**RE: Uranium One USA, Willow Creek ISR Operations, 2013 Annual Inspection Report, Permit No. 478**

## ANNUAL INSPECTION REPORT

**Company:** Uranium One USA, Willow Creek ISR Project, Permit No. 478

**Subject:** 2013 Annual Field Inspection Report

**Photo #6** – View rock energy dissipater type structures in CR Mine Unit 8-4/5.

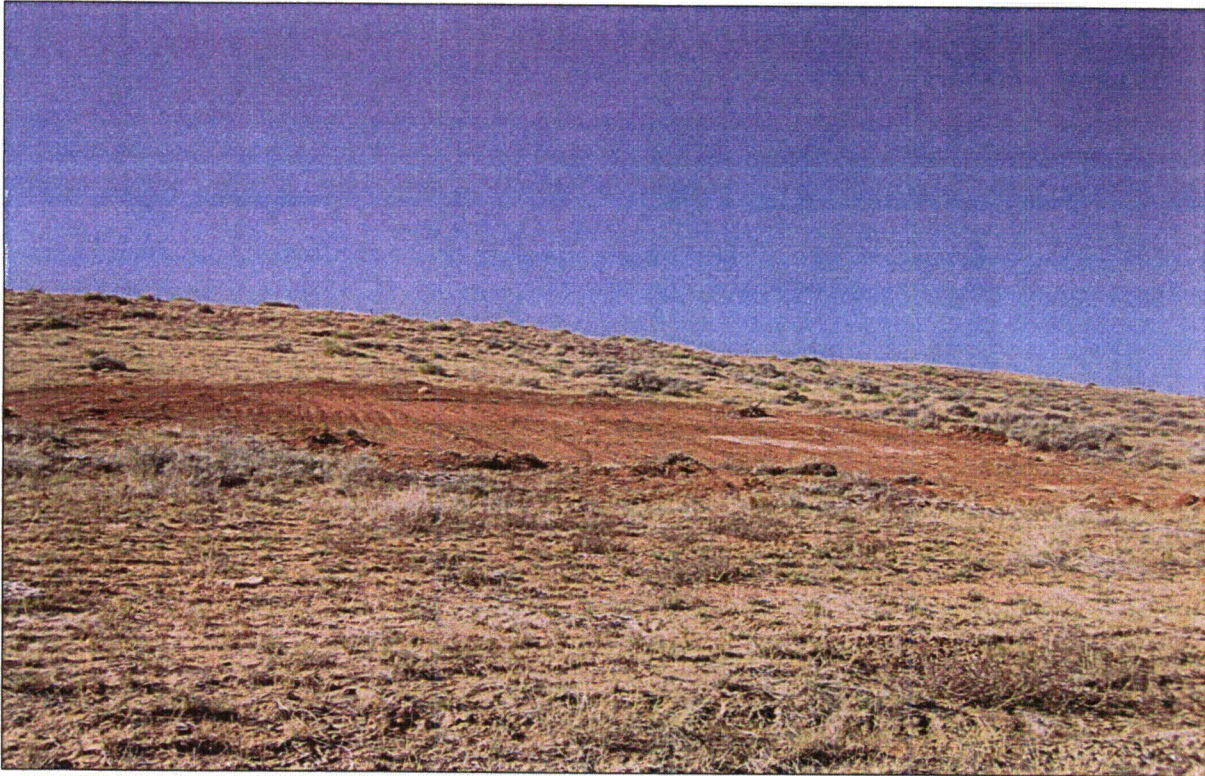
Seeding and sediment control work was active in Module 8-4/5 at the time of the inspection. The area had been effectively recontoured and placement of weed control matting and wattles was observed (**Photos #4 & #5**). Additionally, Uranium One has implemented bedrock cobbles and small boulders turned up during development of the mine unit as energy dissipating type structures to slow surface water run-off and sediment transport. At the time of the inspection, it was not certain how effective these rock structures will be and the Operator was advised to add additional rock energy dissipaters or other erosion control measures to some areas that were showing signs of minor erosion and potential topsoil loss (**Photo #6**).

**Photo #8** – View of historic borehole marking in proposed CR Mine Unit 9.

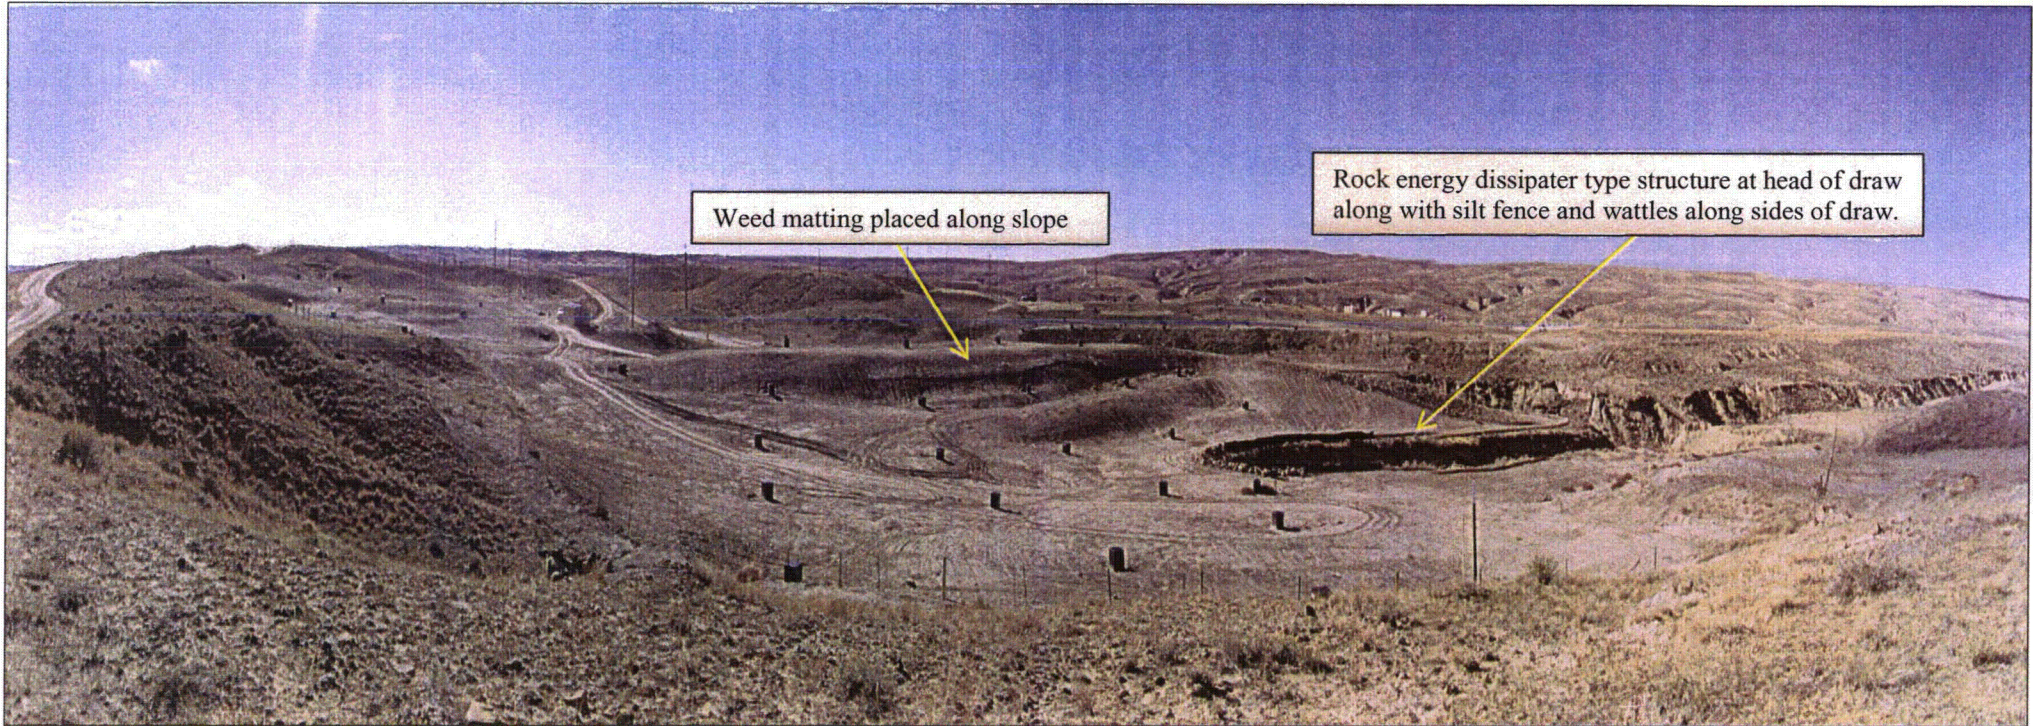
Reclamation of delineation holes in proposed Mine Unit 9 was viewed during the inspection. The sites were drilled in late 2011 and early 2012. The sites had been recontoured, topsoiled and reseeding had been performed within the past month (**Photo #7**). No concerns were noted. Locations where historical boreholes had been identified and plugged and abandoned were marked with a poly pipe riser (**Photo #8**).

**Photo #12** – Disturbance requiring additional sediment control in CR Mine Unit 10B.

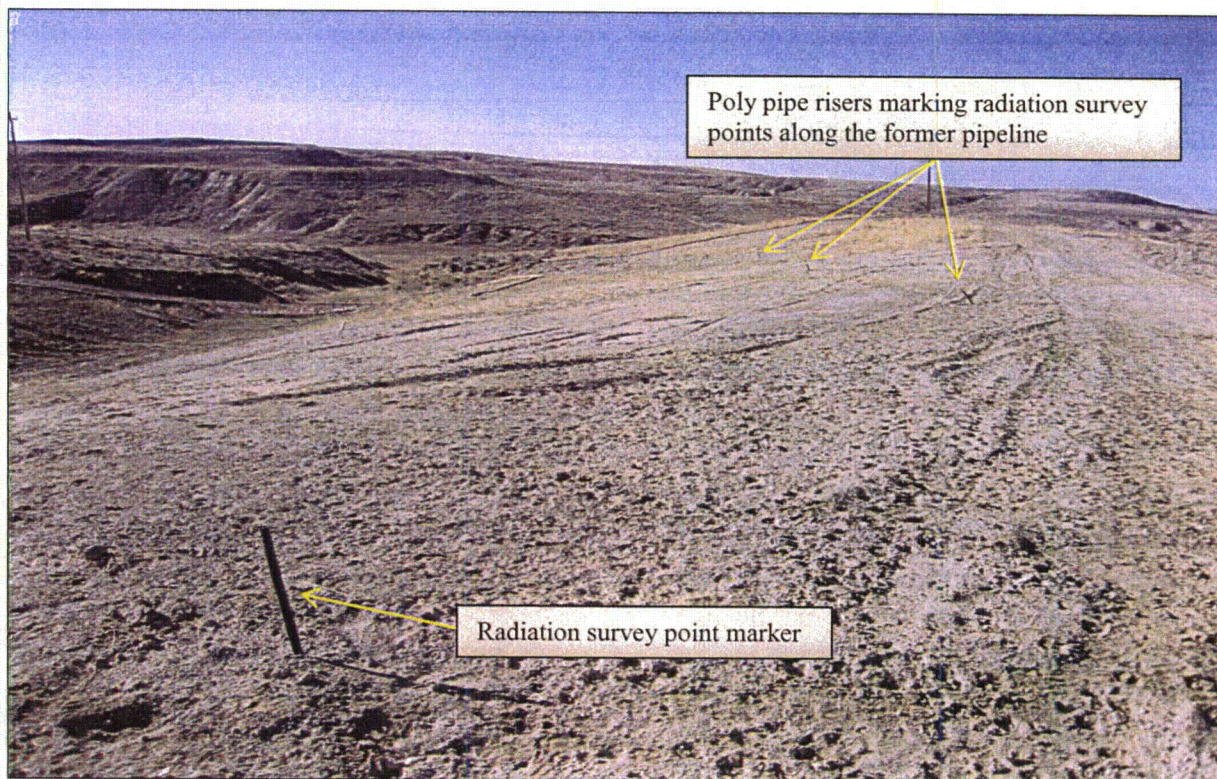
During inspection of the temporarily capped pilot holes, it was evident that additional sediment control was needed in this area of Mine Unit 10 following the recent surface disturbance from drilling operations. Specifically, sediment control is needed to prevent loss of topsoil and sedimentation into adjacent drainages (**Photo #12**). The following day after the inspection, Luke McMahan contacted Uranium One via email and stressed the importance of sediment control in this area. Please note, the email made reference to the subject area as "Mine Unit 11" which was in error. As discussed here, the area of concern is Mine Unit 10, Modules 10-7 and 10-8. The subject email has been placed in the permanent inspection file for Permit No. 478.
